Re: Comments on the August 2007 draft Hazardous Waste Facility Permit
Facility: Los Alamos National Laboratory (LANL)
Facility Owner and Co-Operator: U.S. Department of Energy (DOE)
Facility Co-Operator: Los Alamos National Security, LLC (LANS)
EPA ID No.: NM0899910515

Nuclear Watch New Mexico respectfully submits these comments on the August 2007 draft Hazardous Waste Facility Permit ("Permit") for the Los Alamos National Laboratory. Thank you for considering them. Any quotes herein from the draft Permit are italicized (all pages' line numbers are in the original).

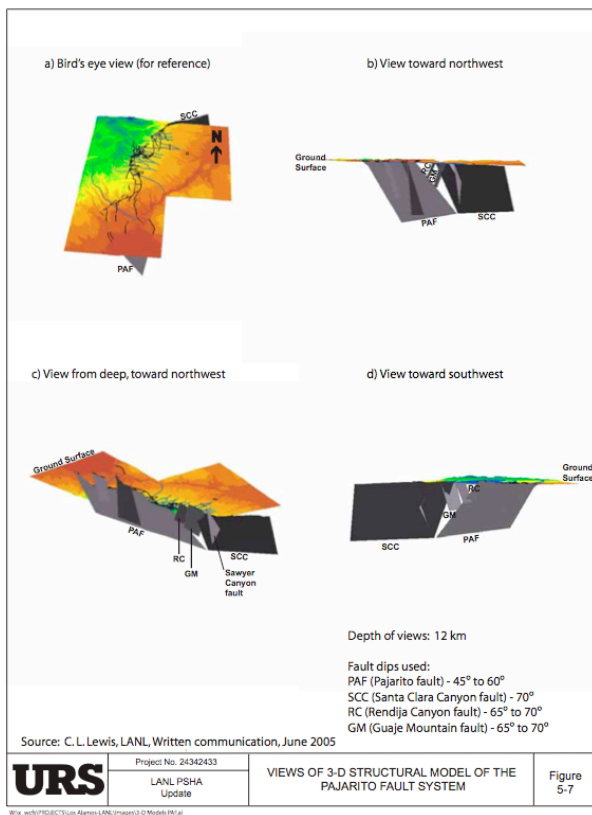
Further evidence of Holocene activity at LANL can be found in “Geology of the Western Part of Los Alamos National Laboratory (TA-3 to TA-16), LA-13960-MS, December 2002” which states, “The youngest known faulting in the study area occurred in Holocene time on a down-to-the-west fault, recently trenched at the site of a new LANL Emergency Operations Center...” The Emergency Operations Center is about 13,700 feet from TA-55.

Figure 5-7 from the PSHA (attached below) shows that the Pajarito fault dips 45 degrees to 60 degrees. This places the fault directly under TA-55 and TA-50 at some point. What is this distance and how will it affect operations and regulations?
